SUBJECT: ISSUANCE OF AMENDMENT (TAC NO. 76934) (TS 285)

BROWNS FERRY NUCLEAR PLANT, UNIT 2

Amendment No. 181  
License No. DPR-52

SAFETY EVALUATION BY THE OFFICE OF NUCLEAR REACTOR REGULATION

- 2. Reactor Pressure  $\leq 800$  psia or Core Flow  $\leq 10\%$  of rated.

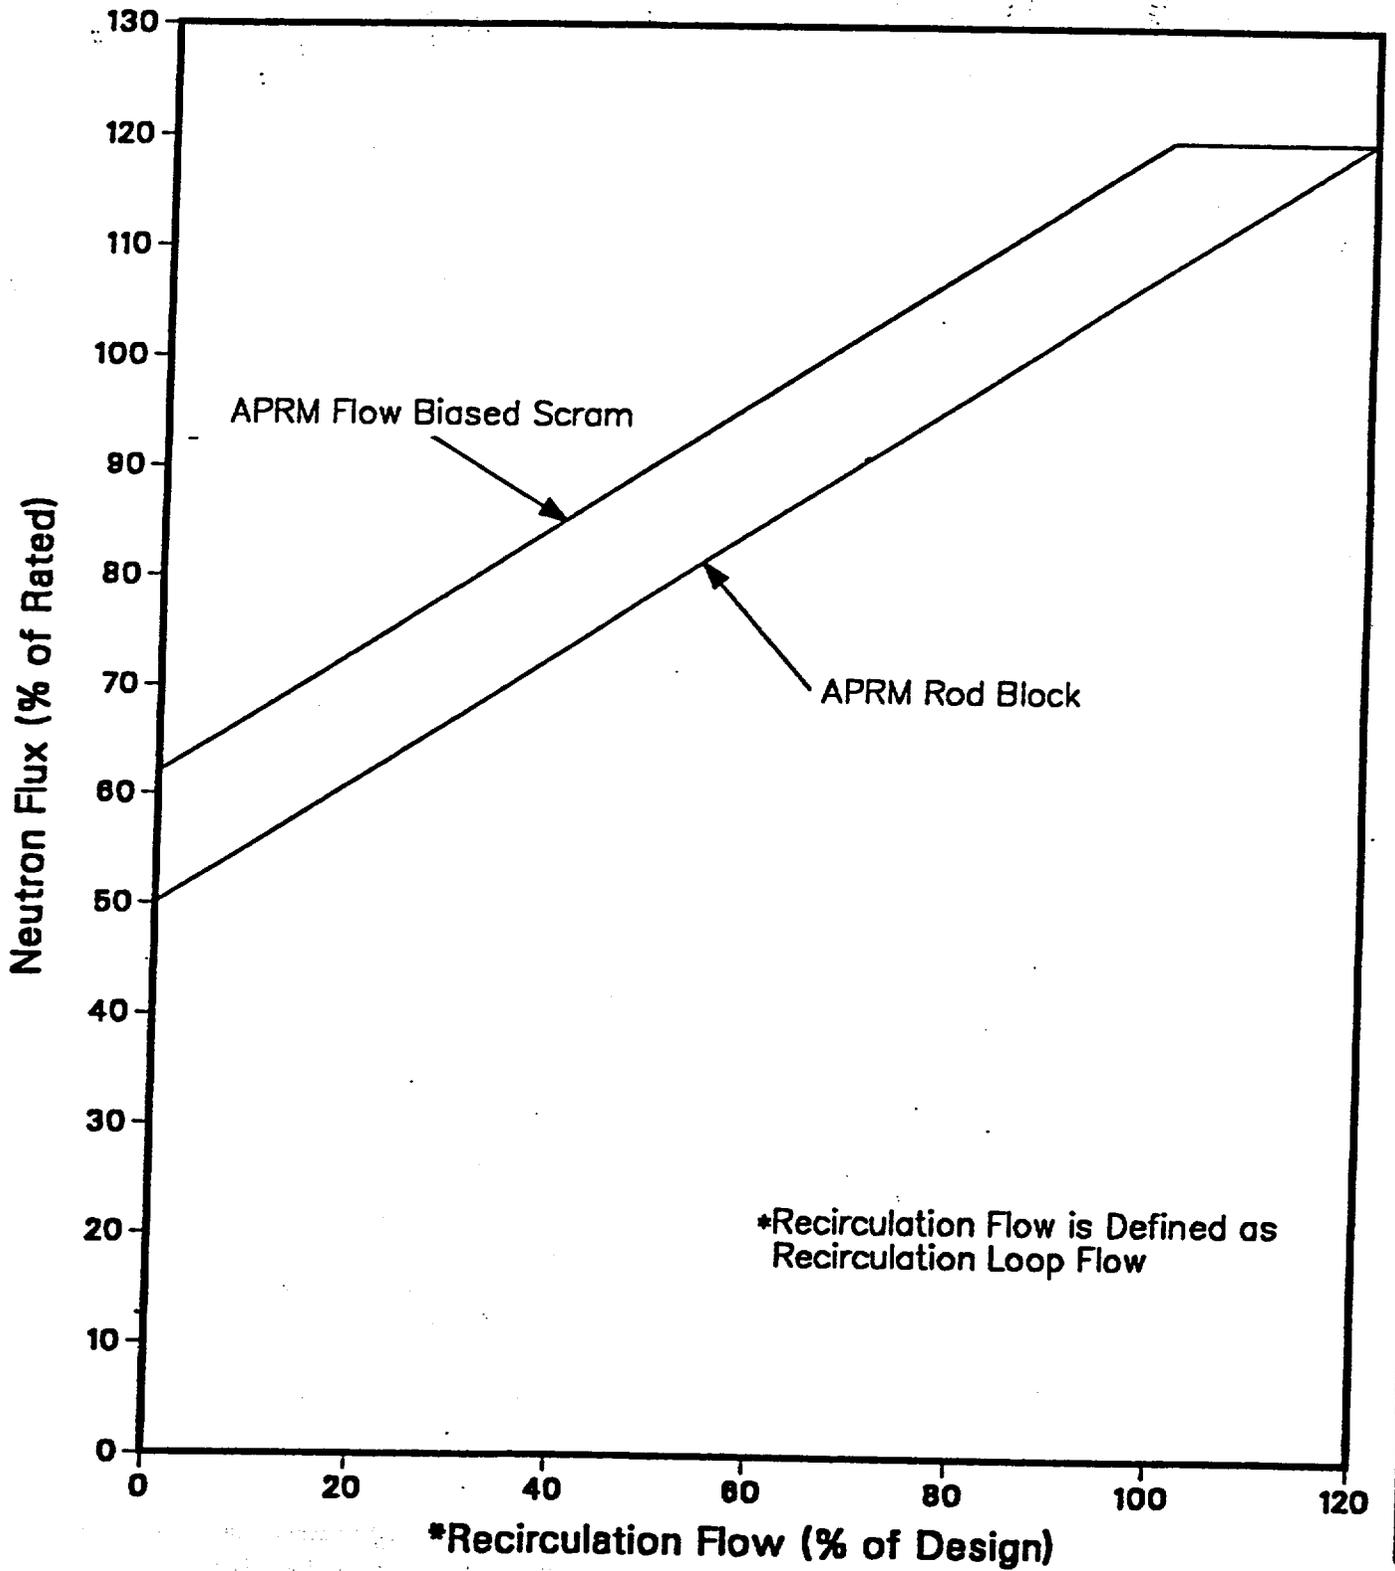
When the reactor pressure is  $\leq 800$  psia or core flow is  $\leq 10\%$  of rated, the core thermal power shall not exceed 823 MWt (25% of rated thermal power).

**APRM Flow Reference Scram and APRM Rod Block Settings**  
**Fig. 2.1-1**

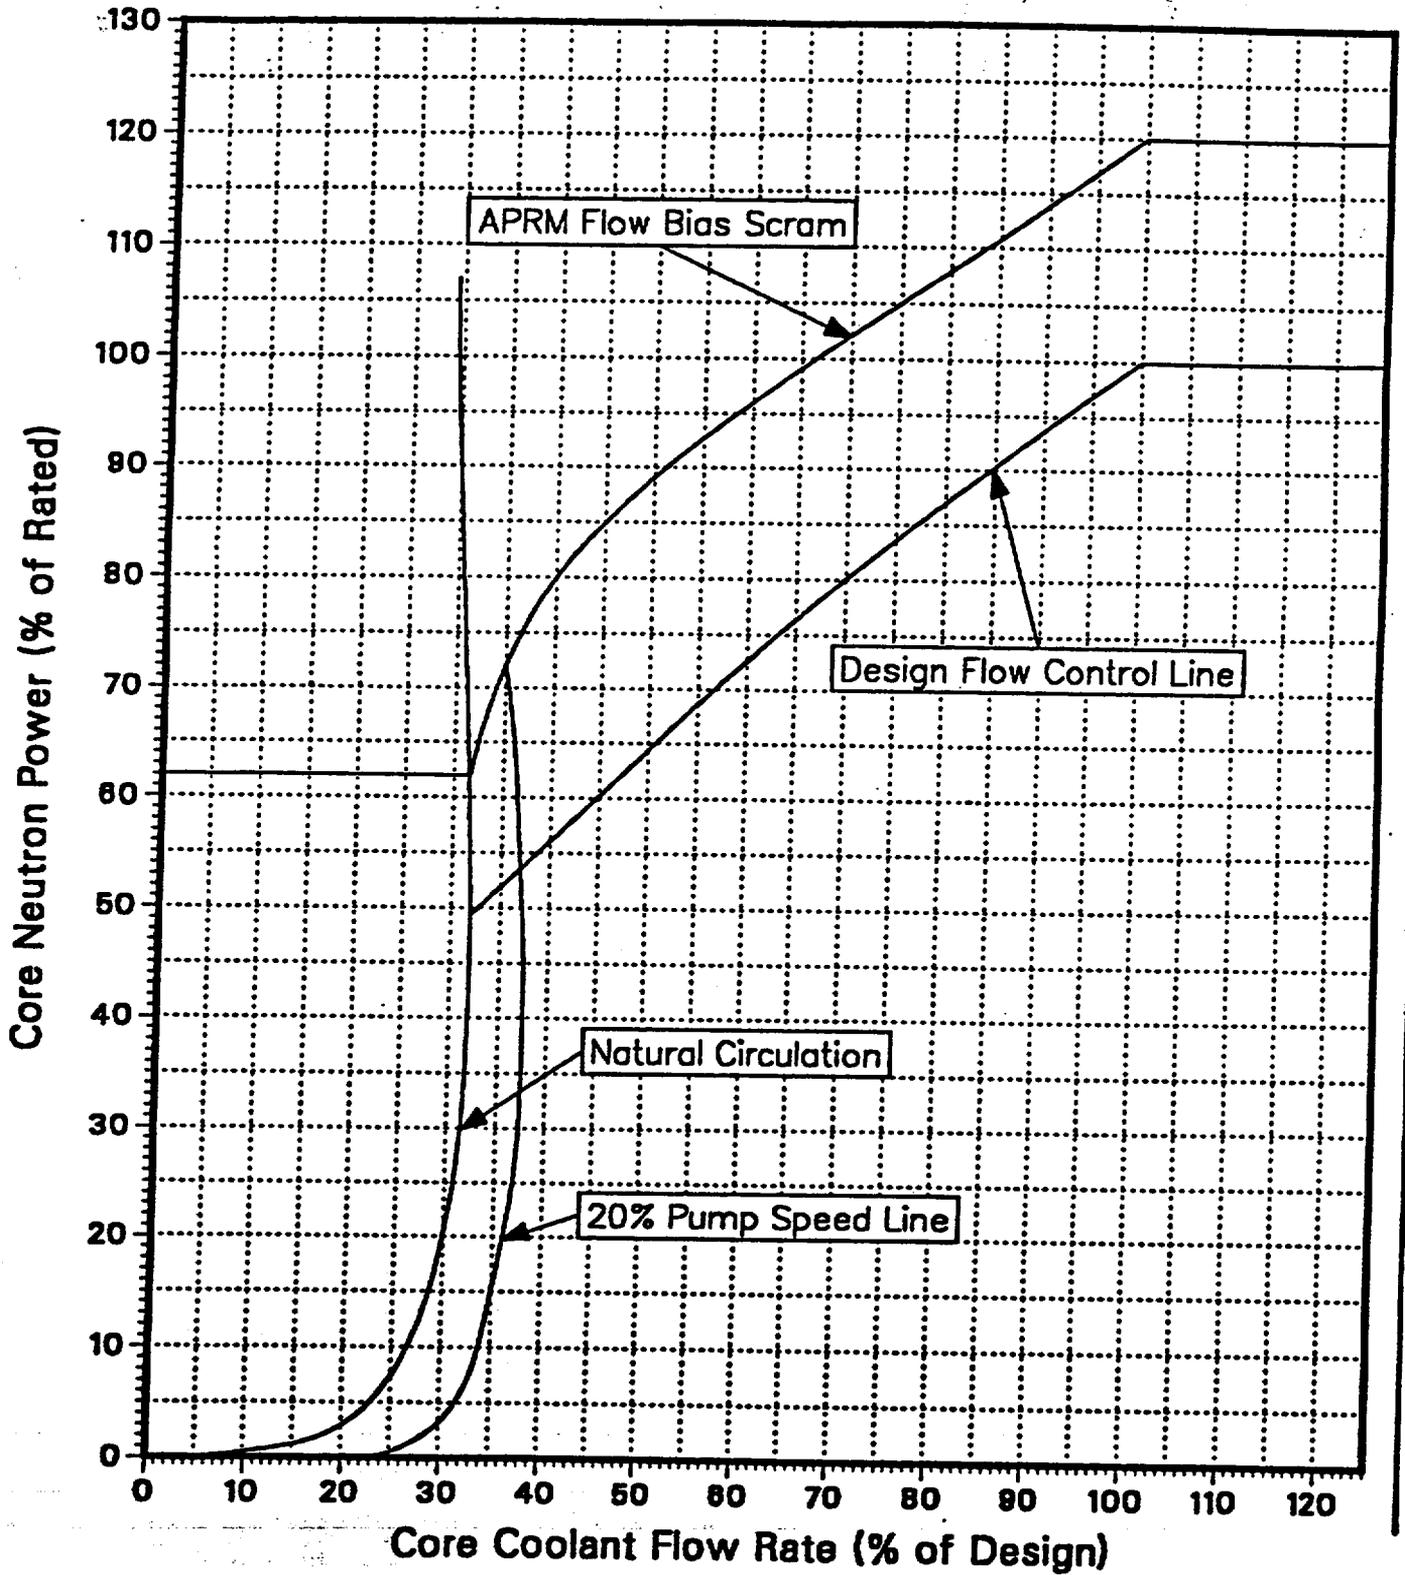
(3) TS Figures 2.1-1 and 2.1-2

Figures are replaced with revised Figures to show the revised flow-biased scram and rod block lines based on equations developed from the trip settings in items (1) and (2) above.
